## AMENDMENTS TO THE 2012 INTERNATIONAL RESIDENTIAL CODE

The following sections, paragraphs, and sentences of the *2012 International Residential Code* are hereby amended as follows: Standard type is text from the IRC. Underlined type is text inserted. ~~Lined through type is deleted text from IRC.~~ A double asterisk at the beginning of a section identifies an amendment carried over from the 2009 edition of the code and a triple asterisk identifies a new or revised amendment with the 2012 code.

**\*\*Figure R602.6.1; delete the figure and insert the following figure:**

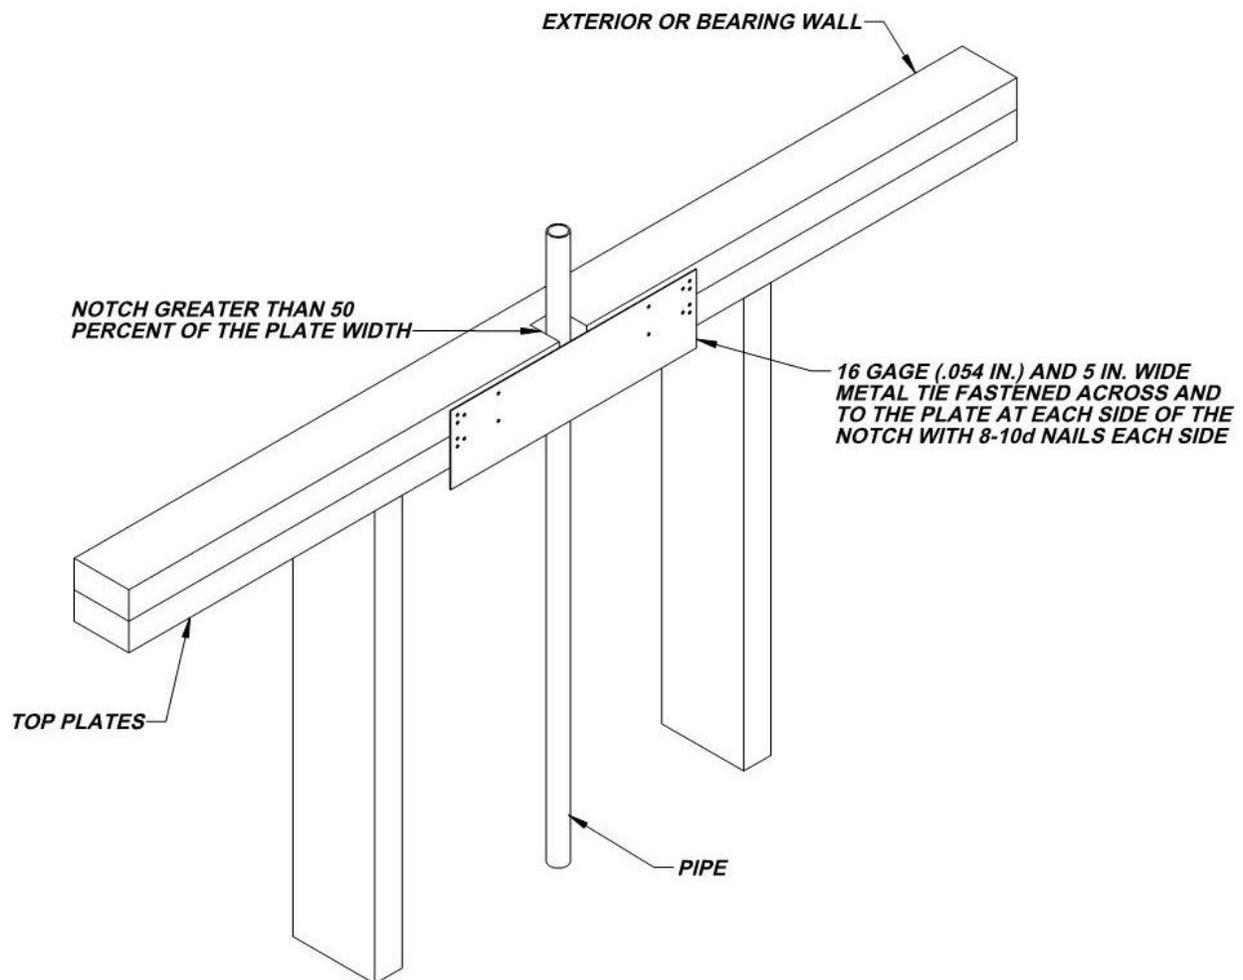
**R602.6.1 Drilling and notching of top plate.** When piping or ductwork is placed in or partly in an exterior wall or interior load-bearing wall, necessitating cutting, drilling or notching of the top plate by more than 50 percent of its width, a galvanized metal tie not less than 0.054 inch thick (1.37 mm) (16 Ga) and 4 ½ inches (38) mm 5 inches (127 mm) wide shall be fastened across and to the plate at each side of the opening with not less than eight 10d (0.148 inch diameter) having a minimum length of 1 ½ inches (38 mm) at each side or equivalent. Fasteners will be offset to prevent splitting of the top plate material. The metal tie must extend a minimum of 6 inches past the opening. See figure R602.6.1. {remainder unchanged}

*(Reason: reflects regional practice and to comply with P2603.2.1. Also provides additional assurance of maintaining the integrity of the framing by spreading the nailing pattern.)*
